Bulletin # SR-5K-0910-01
Release Date: September 13, 2010
Effective Date: September 13, 2010
Supersedes: N/A
Completion Date: Before Operating

SAFETY BULLETIN

Ride Manufacturer: Dartron Industries, Inc.	Affected Production Dates: All
Ride Name: Cliff Hanger	Affected Serial #'s: All
Model #: All

PAGE 3 OF 3 SR-5K-0910-01

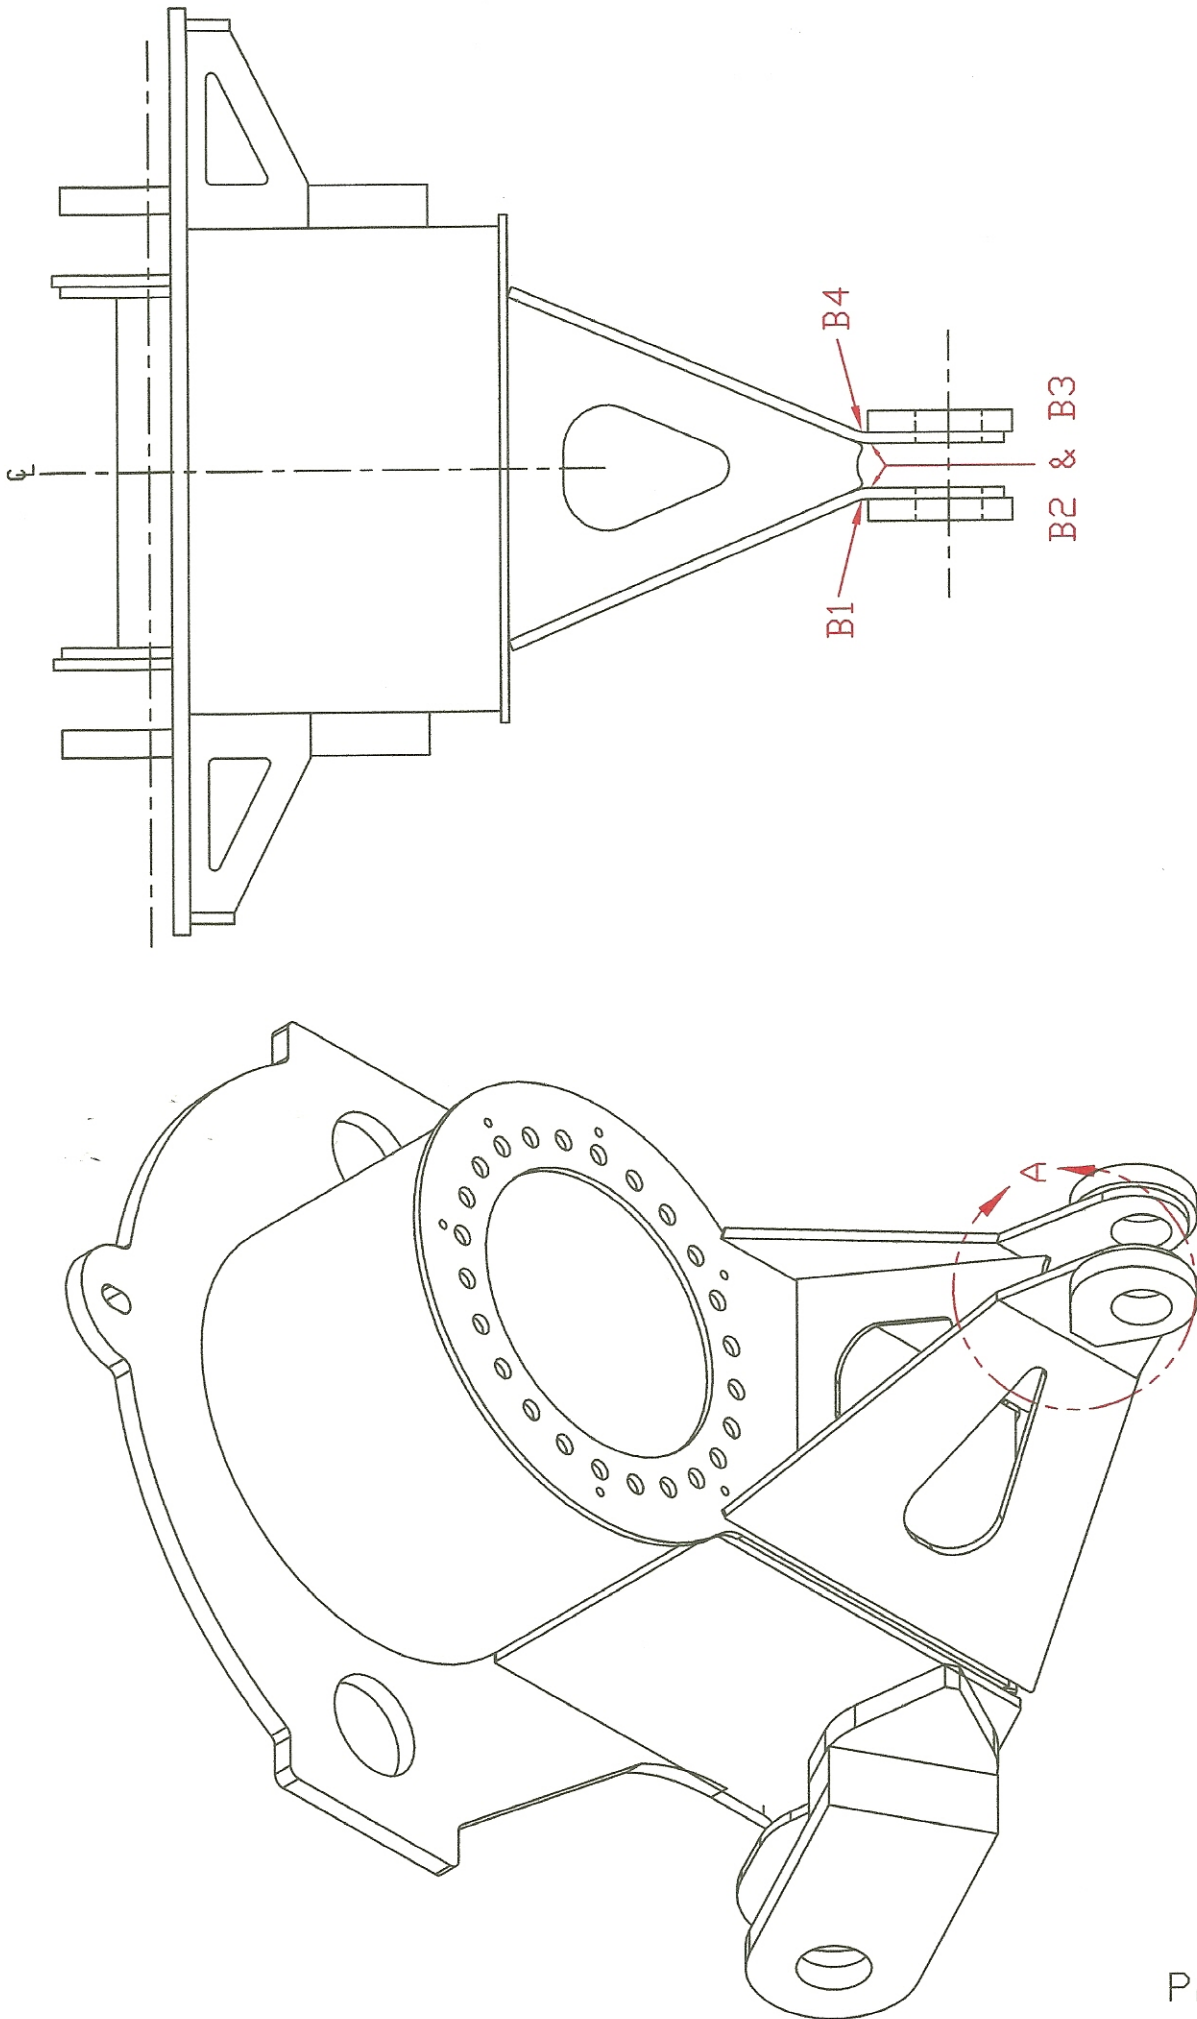
1. No Cliff Hanger is to be operated until the requirements of step 2 through 5 are satisfied.
2. The lower ears of the bearing base (page 3 of 3), both inside and outside at the formed area must be inspected by a certified Level II NDT Inspector using the Magnetic Particle method. Contact Battech at (503) 362-2341 for the NDT Inspection Form. Using the supplied form the NDT Inspector must submit a written report to Battech documenting the results of the NDT inspection.

1. The ride must be set-up to perform this operation.
2. The boom should be raised off the boom rest pad to allow easier access to the areas to be inspected.
3. The areas to be inspected are shown on the drawing on page 3 as detail areas A and B.
4. Both inside and outside at the formed area must be inspected by a certified Level II NDT Inspector using the Magnetic Particle method.
5. If any indications are discovered, please contact Battech Enterprises at (503) 362-2341.
